HISTORIC AND DESIGN REVIEW COMMISSION

HDRC CASE NO: 2022-453
ADDRESS: 228 BARRERA
LEGAL DESCRIPTION: NCB 717 BLK 14 LOT 7
ZONING: IDZ, H
CITY COUNCIL DIST.: 1
DISTRICT: Lavaca Historic District
APPLICANT: NICHOLAS MELDE/Architexas
OWNER: JS&WS HOLDINGS LLC
TYPE OF WORK: Construction of a 2-story residential structure
APPLICATION RECEIVED: August 19, 2022
60-DAY REVIEW: Not applicable due to City Council Emergency Orders
CASE MANAGER: Rachel Rettaliata

REQUEST:

The applicant is requesting conceptual approval to construct a new 2-story, single-family residence totaling approximately 1,640 square feet with an attached carport.

NORTH ELEVATION
SCALE: 1/4" = 1'-0"

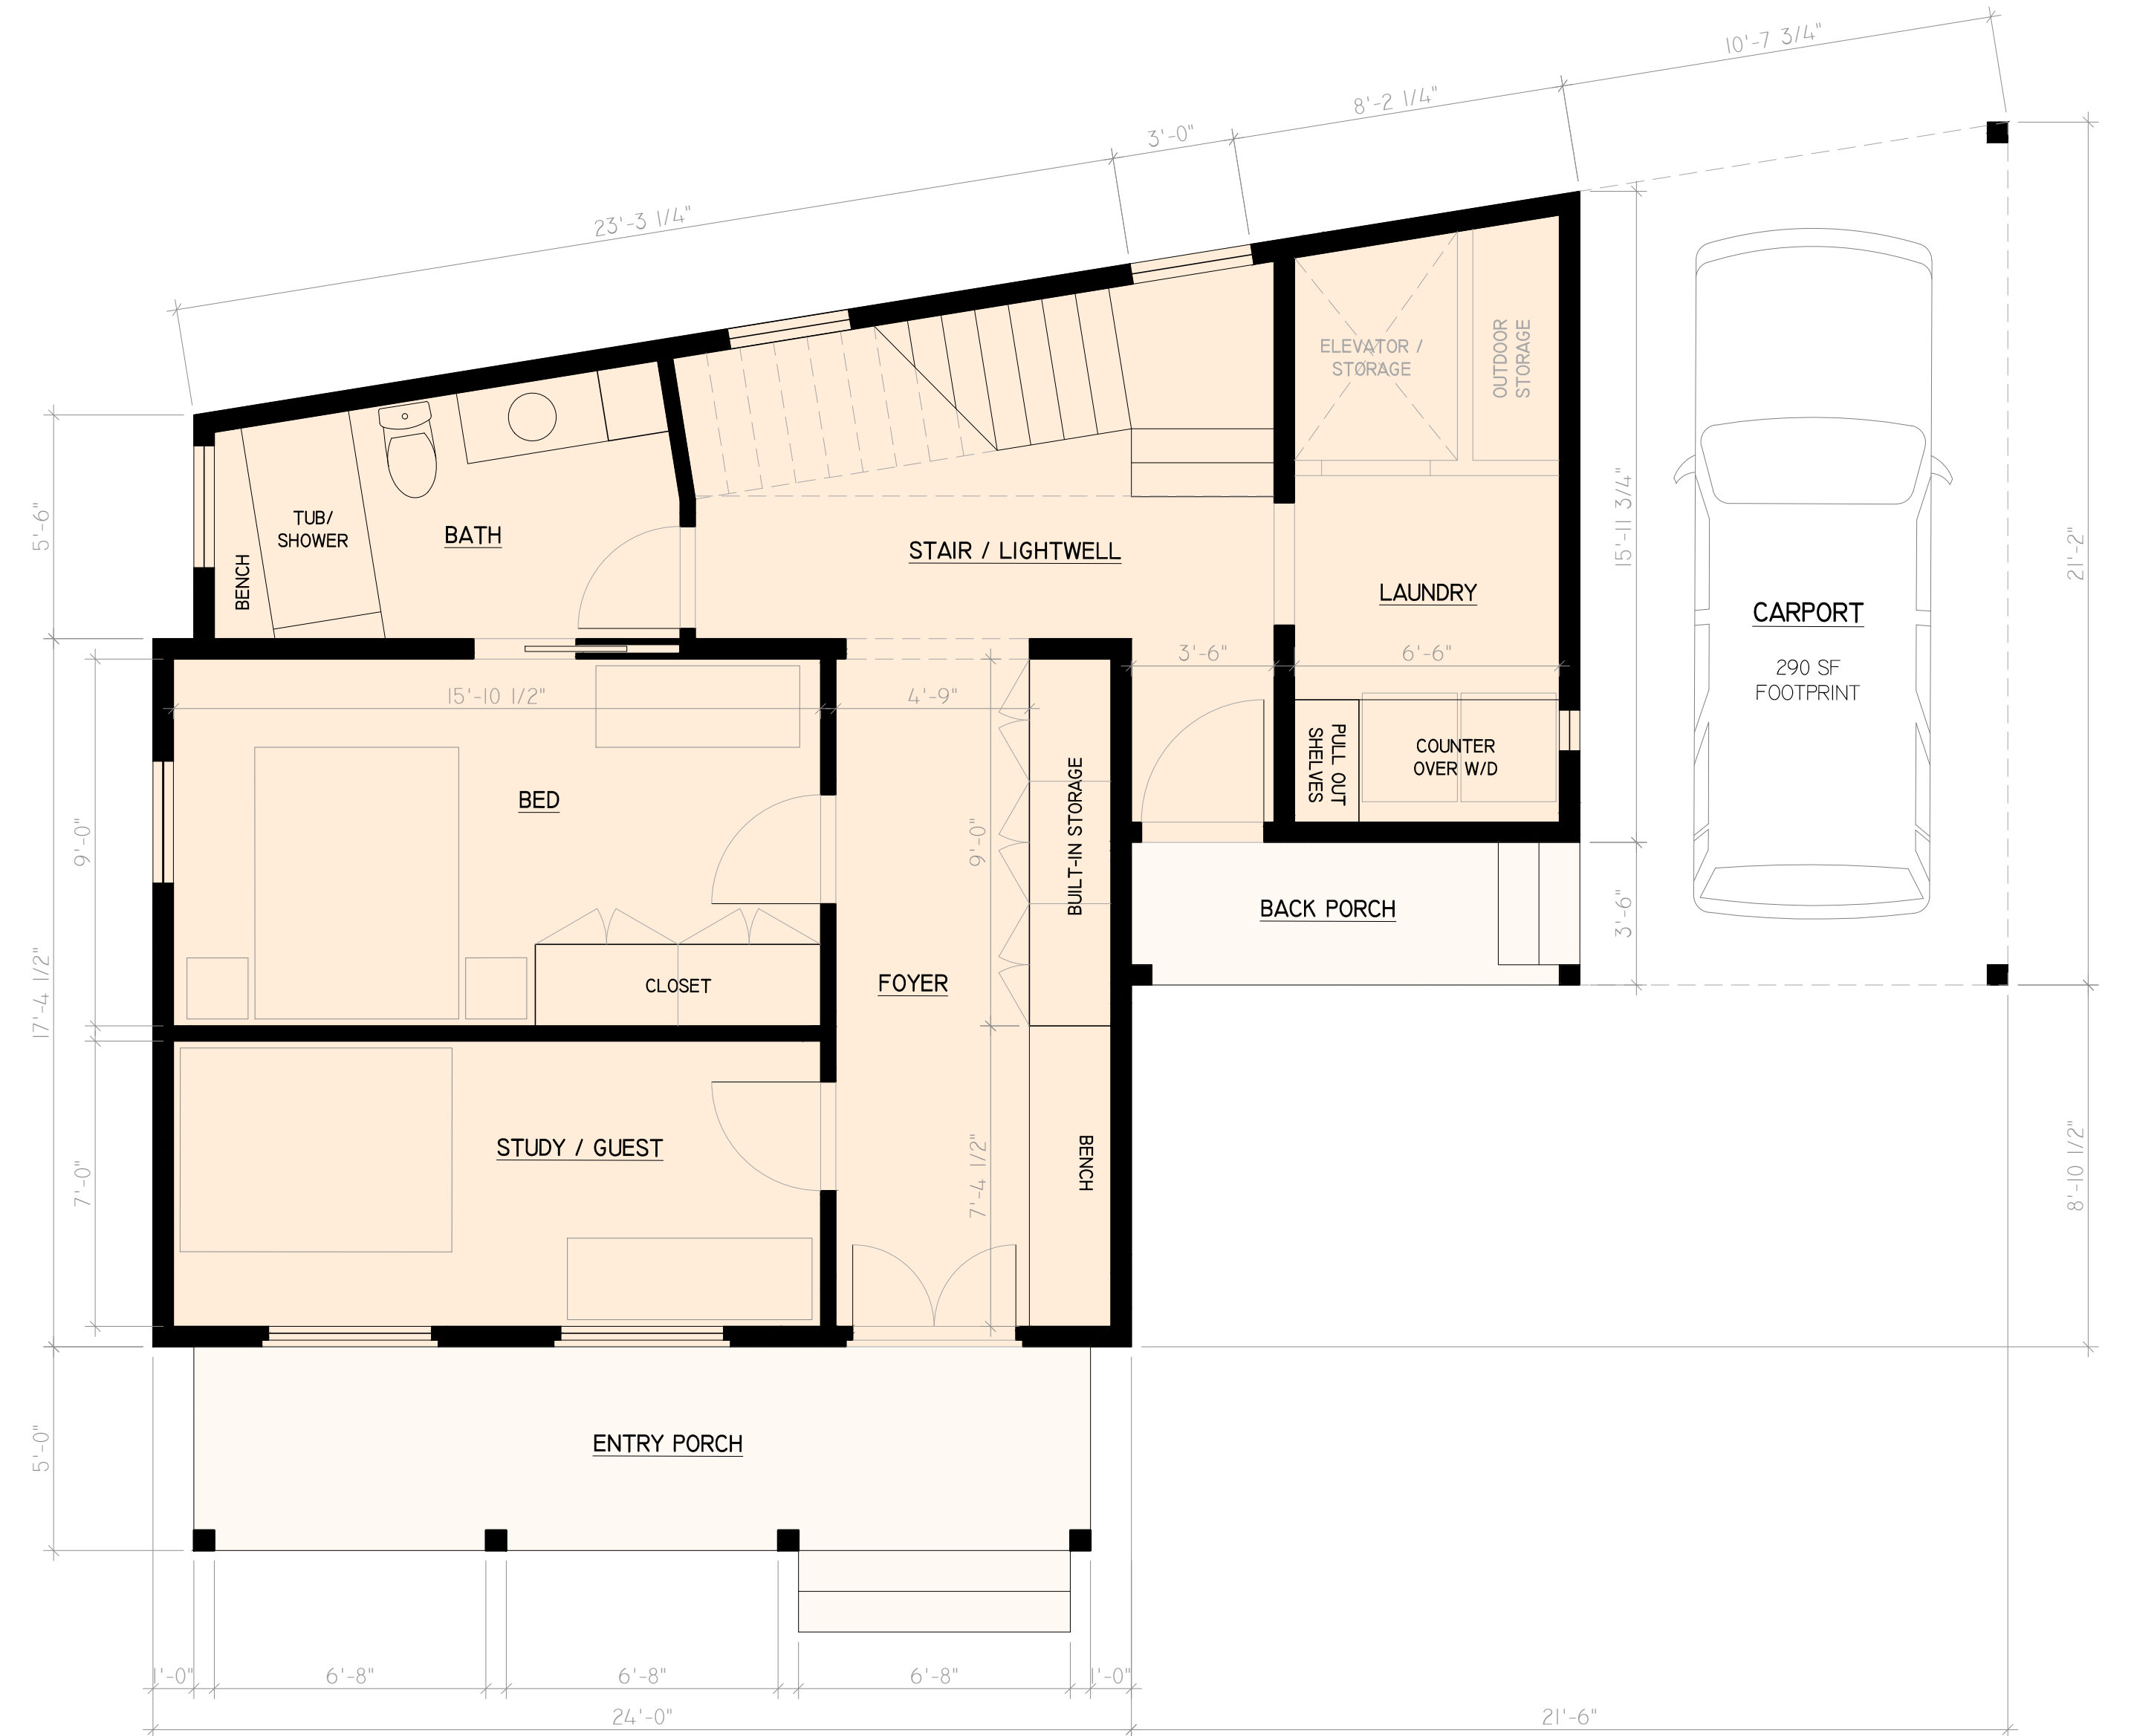
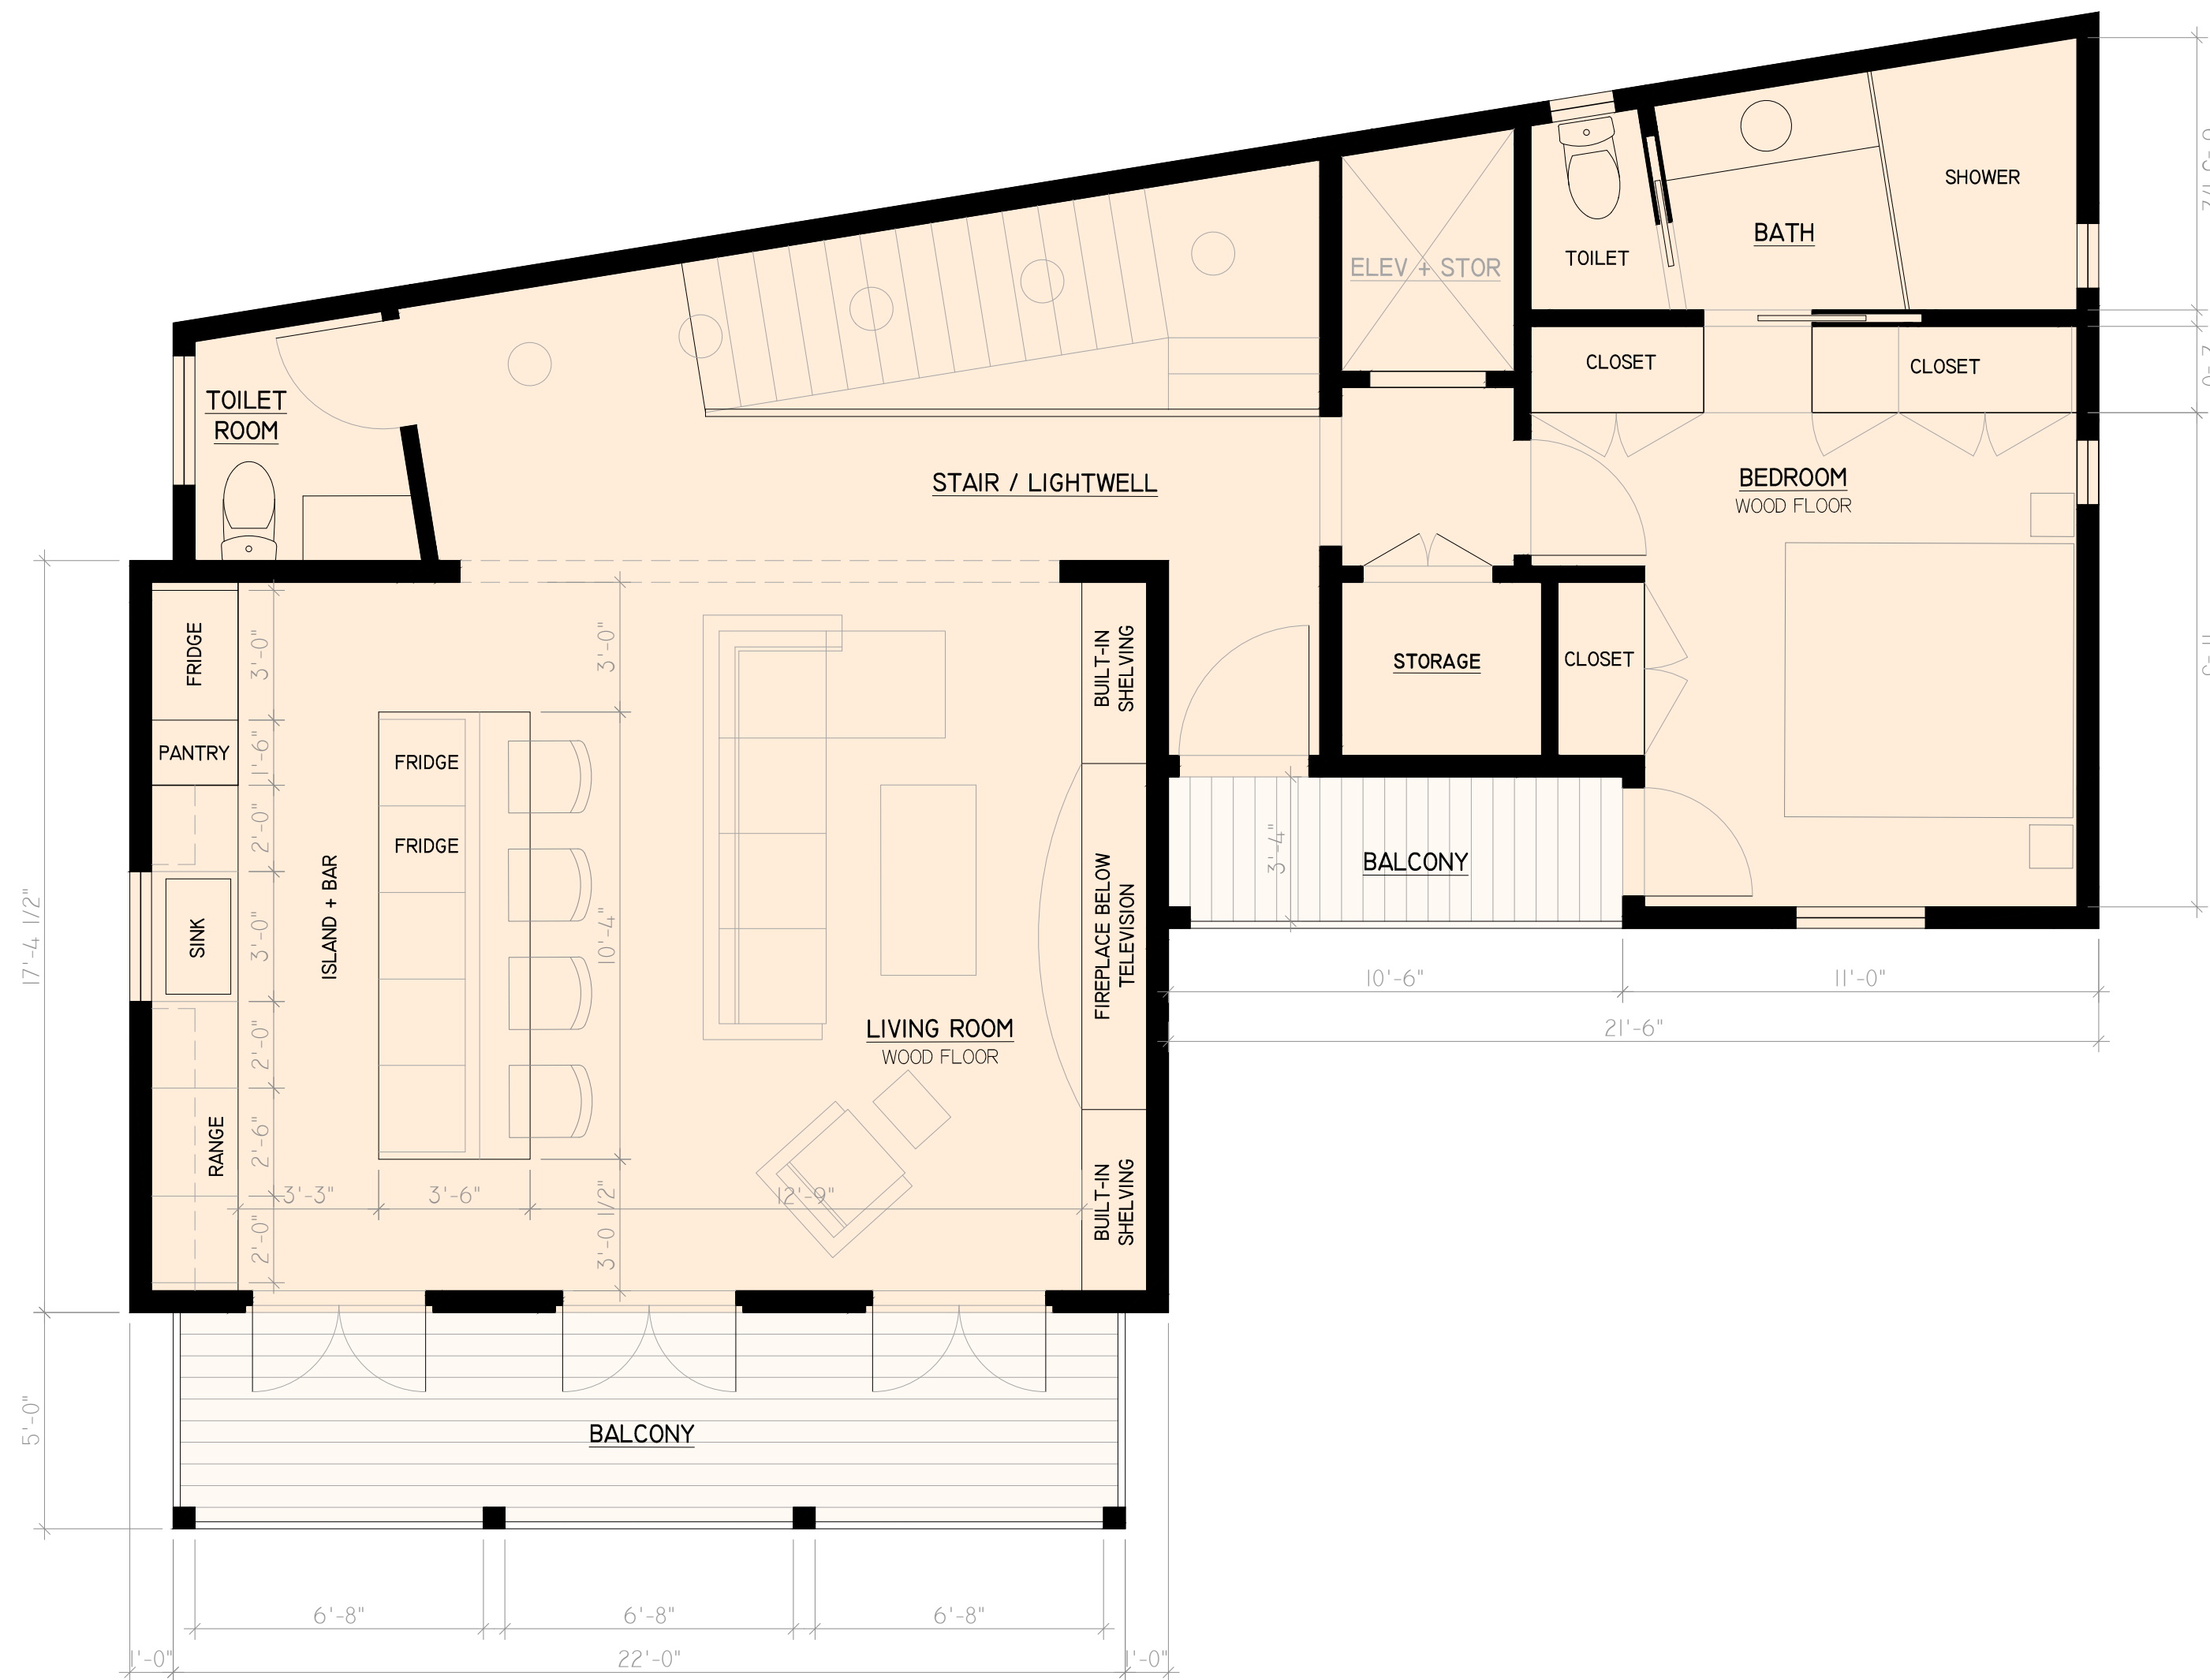
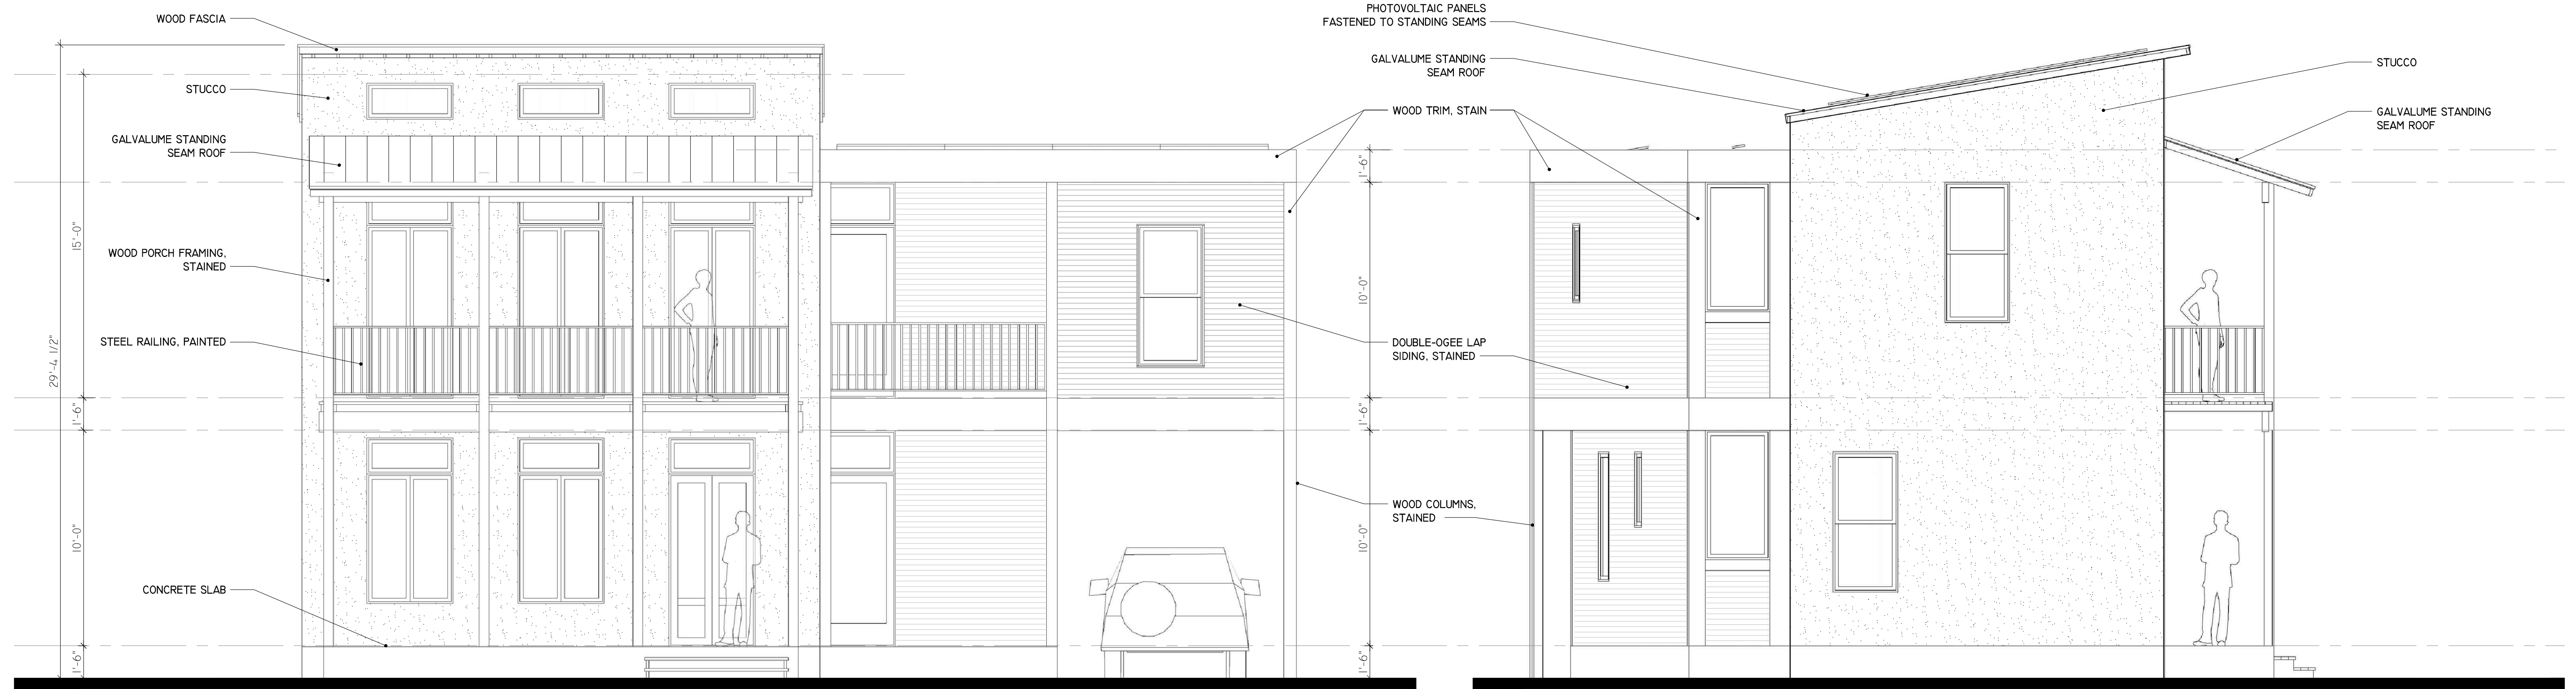
- e. SCALE AND MASSING – The applicant has proposed to construct a 2-story residential structure with a second-story extension to accommodate a row of clerestory windows. According to Guideline 2.A.i for New Construction, new structures should feature a height and massing that is similar to historic structures in the vicinity. In residential districts, the height and scale of new construction should not exceed that of the majority of historic buildings by more than one story. The block within the Lavaca Historic District features 1-story and 2-story historic structures and 2-story units of new construction. The block to the east of Indianola features 2-story infill. The applicant has submitted foundation heights of 1'-6." Staff finds that the proposed scale and massing of the structure appears generally appropriate.

- f. ROOF FORM – The applicant has proposed a shed roof and a flat roof form. According to Guideline 2.B.i

for New Construction, new construction should feature roof forms that are consistent with those predominantly found on the block. The adjacent structures on Barrera feature front gable, cross gable, pyramidal, hip, flat, and shed roof forms. The neighboring contemporary structure features a shed roof form paired with a front gable roof form. Staff finds the proposal consistent with the Guidelines.

- h. MATERIALS AND TEXTURES – The applicant has proposed to construct the residence with 3-coat, color-integrated stucco cladding and wood lap siding with a double-ogee waterfall profile with a semi-transparent stain, a galvalume standing seam metal shed roof on the primary volume and TPO low-sloped roofing over the secondary volume with an 8-inch-tall parapet, aluminum-clad wood windows and doors, wood front porch posts and framing, and a metal balcony railing. Guideline 3.A.i for New Construction stipulates that new construction should use materials that complement the type, color, and texture of materials traditionally found in the district. Materials should not be so dissimilar as to distract from the historic interpretation of the district. For example, corrugated metal siding would not be appropriate for a new structure in a district comprised of homes with wood siding. Consider using traditional materials, such as wood siding, in a new way to provide visual interest in new construction while still ensuring compatibility. Staff finds the proposed materials to be generally appropriate.

- i. WINDOW MATERIALS – The applicant has proposed to install aluminum-clad wood fixed, transom, and one-over-one windows. The aluminum-clad wood windows should feature an inset of two (2) inches within facades and should feature profiles that are found historically within the immediate vicinity. An alternative window material may be proposed, provided that the window features meeting rails that are no taller than 1.25” and stiles no wider than 2.25”. White manufacturer’s color is not allowed, and color selection must be presented to staff. There should be a minimum of two inches in depth between the front face of the window trim and the front face of the top window sash. This must be accomplished by recessing the window sufficiently within the opening or with the installation of additional window trim to add thickness. Window trim must feature traditional dimensions and an architecturally appropriate sill detail. Window track components must be painted to match the window trim or be concealed by a wood window screen set within the opening. Faux divided lites are not permitted. Staff finds that all windows installed should feature traditional operations and that the applicant should submit product specifications for review prior to returning to the HDRC.

- l. CARPORT – The applicant has proposed to construct an attached front-facing, single-bay carport on the west side of the property. Guideline 5.A.i for New Construction states that new garages and outbuildings should be designed to be visually subordinate to the principal historic structure in terms of their height, massing, and form. The carport is proposed as a distinct volume that is set back 8’-10” from the front façade wall plane of the main volume. According to Guideline 5.B.i for New Construction, the predominant garage orientation found along the block should be matched. Do not introduce front-loaded garages or garages attached to the primary structure on blocks where rear or alley-loaded garages were

- i. That the applicant submits window specifications to staff for review prior to returning to the HDRC based on finding i. Wood or aluminum-clad wood windows are recommended. Windows should feature traditional operations, an inset of two (2) inches within facades, and profiles that are found historically within the immediate vicinity. White manufacturer’s color is not allowed, and color selection must be presented to staff. There should be a minimum of two inches in depth between the front face of the window trim and the front face of the top window sash. This must be accomplished by recessing the window sufficiently within the opening or with the installation of additional window trim to add thickness. Window trim must feature traditional dimensions and architecturally appropriate sill detail. Window track components must be painted to match the window trim or concealed by a wood window screen set within the opening.
